**PLANNING BOARD AGENDA**

**JUNE 13, 2022  
REGULAR MEETING**

**Re: Completeness/Technical Review #3  
Elithy Use Variance  
1900 Main Street  
Block 13, Lot 40  
H2M Project No. LKCP 2108**

**Re: Completeness/Technical Review  
MSA Architects Use Variance (Vail)  
1819 Fernwood Road  
Block 13, Lot 7  
H2M Project No. LKCP 2108**

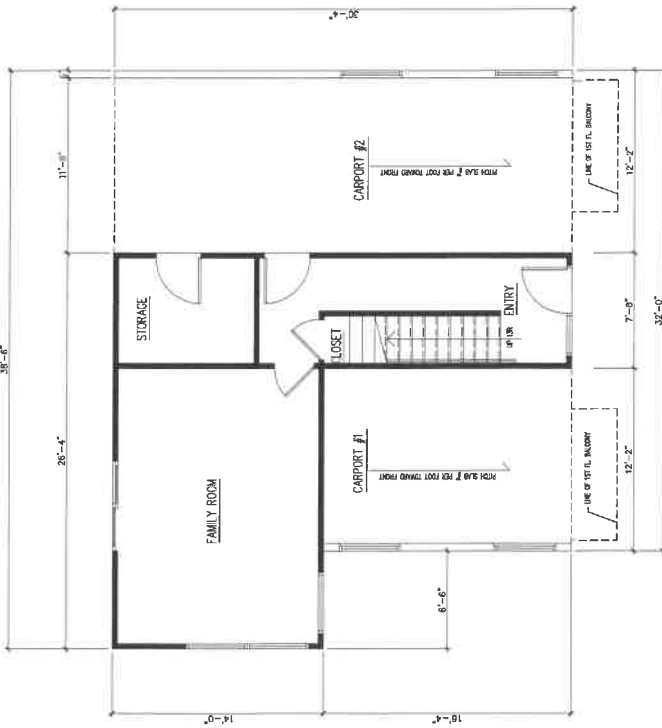
3. The revised Variance Plan depicts a more useful on-site stormwater disposal system that appears to be sized properly; however, there are two issues that must be resolved as follows:
- The plan does not depict the leaders and gutters to connect to the proposed recharge system; and
  - The plan would force the system to fail to the rear of the property, where it would have to rely on the watertightness of the landscape wall to keep stormwater from passing to the properties in the rear.

The Board should elicit testimony regarding these issues to vet the anticipated performance of the drainage system.

4. The Applicant proposes to introduce a low retaining wall for the bulk of the side yard and across the rear likely to facilitate the proposed drainage scheme, which in theory seems sound but has problems as identified in Item 3 above. At one point, the proposed wall would be 2 feet higher than the adjacent grade. My concern has to do with any fencing that may be proposed in the future whereby a 6 foot high fence is installed, and it appears that that fence is 8 feet high to the neighbor. The Board should condition any approval on developing a detail that will ensure such an outsized installation cannot happen.

5. The plan is silent with regard to where mechanical equipment may be located. The Board should elicit testimony regarding these installations and require the plans to be revised to include same.

6. The plan calls for the installation of pavers beyond the property line (e.g. into the right of way). This proposed condition is well outside of the norm along Main Street. The Board should consider conditioning any approval on limiting paver use to the Applicant's property only and require concrete curb and sidewalk replacement and along the entire frontage of the subject lot. The Board should also question the need for two curb cuts in an area where street parking is at times at a premium.

PROPOSED RIGHT SIDE ELEVATION  
SCALE: 1/4" = 1'-0"

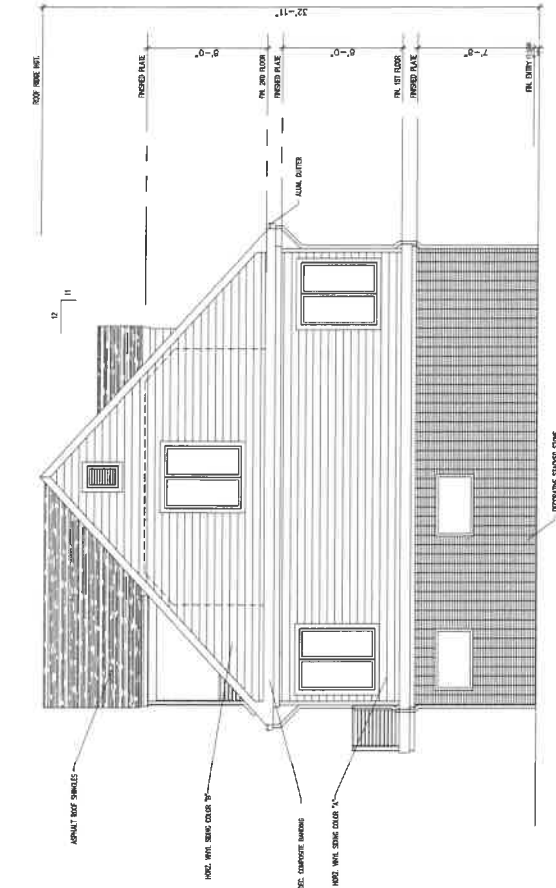
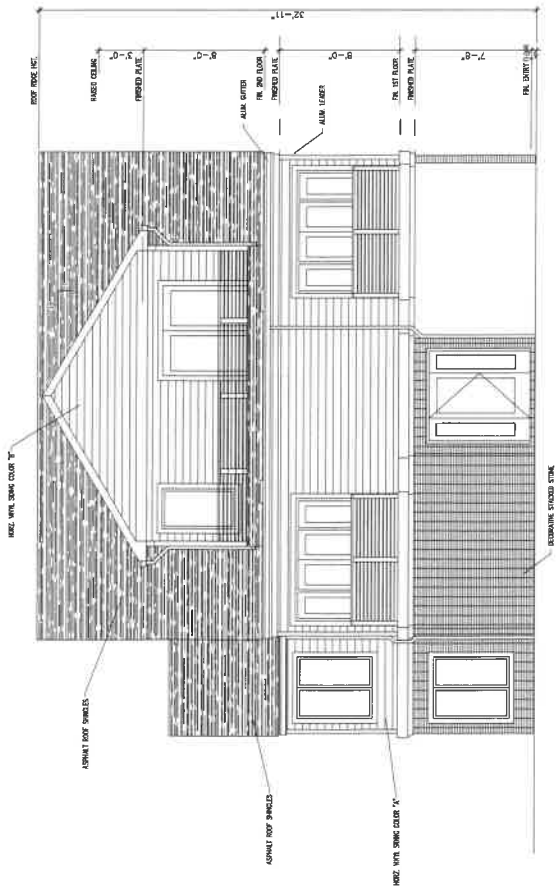
1. Code Section 17-9.3(a) sets forth the permitted principal uses in the GB Zone. Review of these uses revealed that stand-alone residential uses are not permitted in this zone. The Applicant proposes a single-family residential use on this small lot. A Use Variance (d(1)) will be required for this proposed non-conformity.

- Lot Area – 7,000 square feet required; 3,100.10 square feet existing;
- Lot Frontage – 50 feet required; 40 feet existing;
- Lot Width – 50 feet required; 46.17 feet existing;
- Lot Depth – 100 feet required; 63.92 feet existing;
- Front Yard Setback – 20 feet required; **12.79 feet proposed**;
- Rear Yard Setback – 20 feet required; **11.24 feet proposed**; and
- No. of Stories – 2-1/2 maximum allowable, **3 stories proposed**.

The existing non-conforming conditions cited above are provided for the Board's information. Bulk variances will be required for the remainder of the proposed non-conformities **bolded** above.

1819 FERNWOOD ROAD  
LOT 7 BLOCK 13

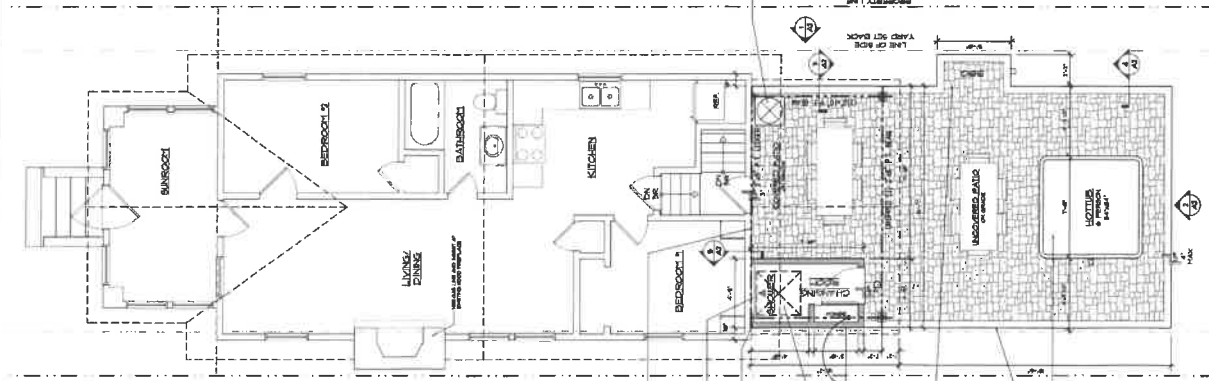
1. Code Section 17-9.1 sets forth the yard, area and building requirements for the R-40 Zone. My review of these requirements in conjunction with the subject application identified the following inconsistencies:
  - Lot Area – 4,000 square feet required; 2,179 square feet existing;
  - Lot Frontage – 40 feet required; 25.28 feet existing;
  - Lot Width – 40 feet required; 25.28 feet existing,
  - Front Yard Setback – 20 feet required; 12.1 feet existing (to enclosed porch) and 6 feet existing (to front steps);

- Side Yard Setback (North Side) – 3 feet required; 2.2 feet existing (to first floor); and
- Building Height – 22.12 feet maximum allowable (63.2% of 35 feet); 19.83 feet existing and **24.16 feet proposed**.

The existing non-conforming conditions cited above are provided for the Board's information. A bulk variance will be required for the proposed building height **bolded** above.

2. Code Section 17.10 requires two (2) off-street parking spaces for a four-bedroom residential dwelling. The site currently has no legal off-street parking and no new parking spaces are proposed. **A variance will be required for these existing/proposed conditions.**
3. The survey depicts that the existing sidewalk spans the front property line and encroaches on the Applicant's property. The Board should condition any approval on the Applicant providing an easement to allow the sidewalk to remain in perpetuity.
